**Sizewell C Development Consent Order ('DCO') Application**  
**Woodbridge Town Council (IP20025891) – Deadline 2 submission**  
**on Change 1 documents**

**Review of Railway Freight Transport with specific reference**  
**Viability, Noise and Vibration impact in Woodbridge**

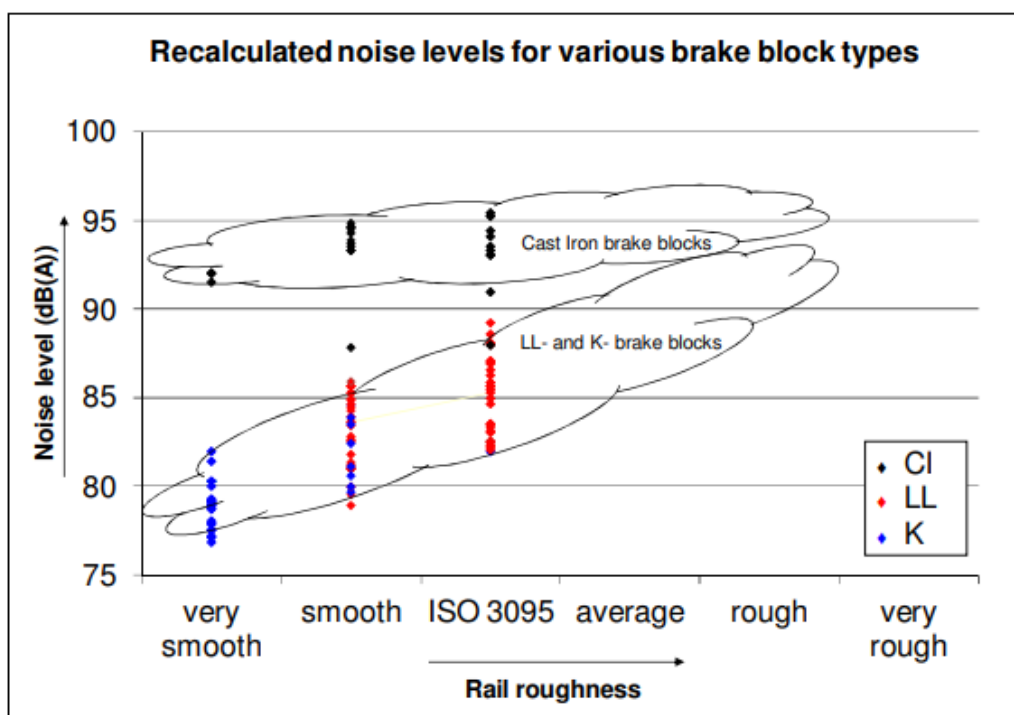
49. Train klaxons for the class of trains to be used for Sizewell C are required by the Railways Group standard GM/RT 2131 sub-section 2.2.1 (page 7) to emit sound producing, at a minimum, an equivalent to 86 – 94dB(A) at 25m distance from the track. This is over 3 magnitudes higher than a rolling 10mph Class 66 traction unit.

50. The noise isochron evidence presented by NNBG CL does not reflect the sound generated by train klaxons. This omission, given the very high sound level of the klaxons, underestimates the impact of rail traffic noise on properties and the Deben Estuary RAMSAR and SPA adjacent to the railway line through Woodbridge. The noise mitigation strategy may be impacted by this omission.
